Serial No.: 10/078,713

Response to Office Action of February 22, 2005

Amendments to the Drawings:

Fig. 1

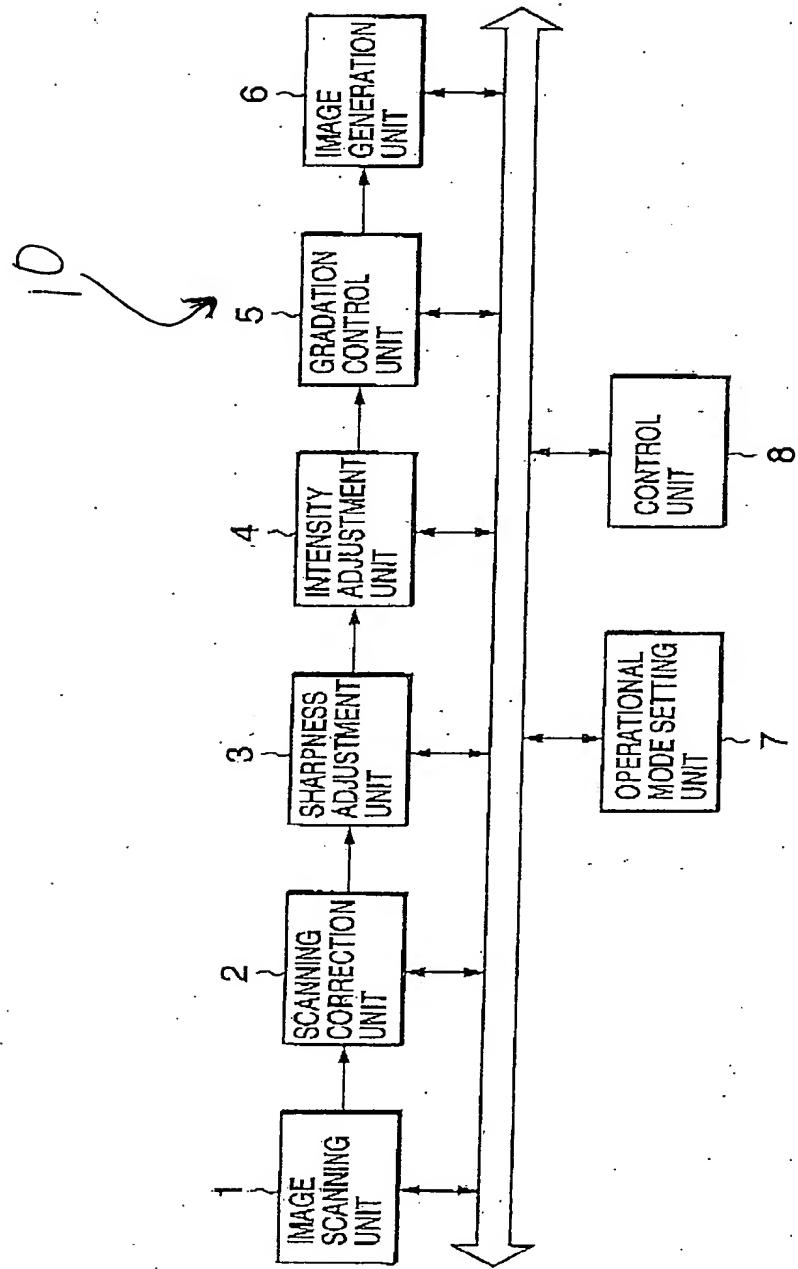
The Examiner has objected to Figure 1 for missing reference numeral 10 as stated on line 15 in page 4 of the current application. Accordingly, Figure 1 has been amended to incorporate the reference numeral. In addition, Figure 4 has been also amended as will be explained below.

In Fig. 1, reference number 10 has been added above the image processing apparatus.
